UN/SCETDG/50/INF.7/Add.2 UN/SCEGHS/32/INF.5/Add.2

Revision of the Manual of Tests and Criteria: Part I: Section 18

**Transmitted by the Chairman of the Working Group on Explosives on
behalf of the Working Group**

Figure 18.7.1.1: VENTED PIPE TEST

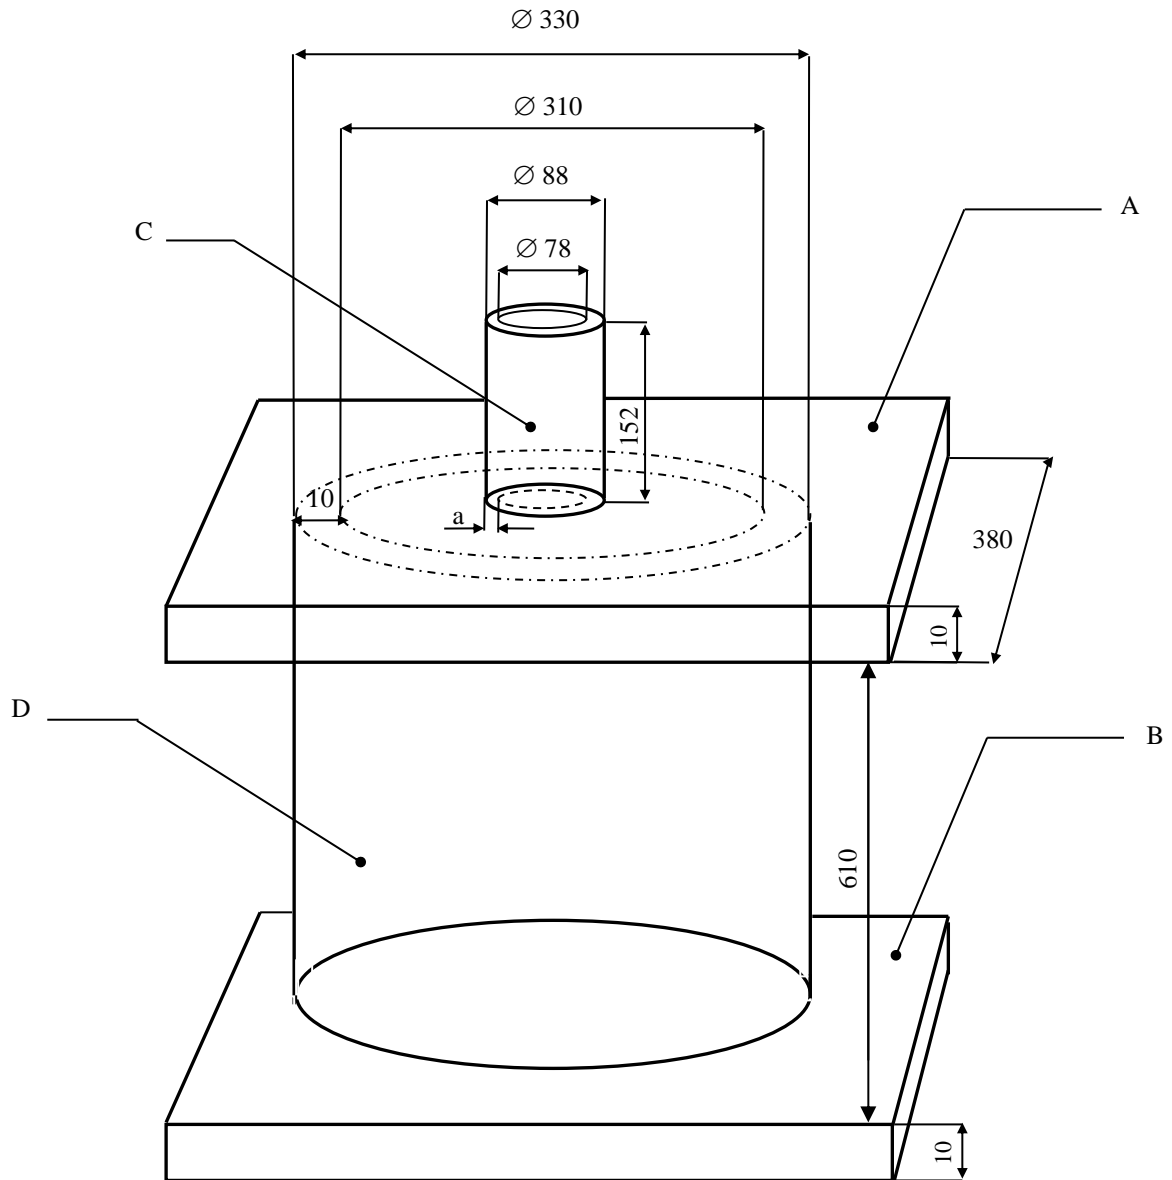
The test result is considered “+” and the substance should not be ~~contained + transported~~ in portable tanks as ~~a dangerous good of Division 5.1~~ an oxidizing substance if an explosion and/or fragmentation of the pipe, as specified in Section 18.7.1.3.3 (e) and (f) is observed.
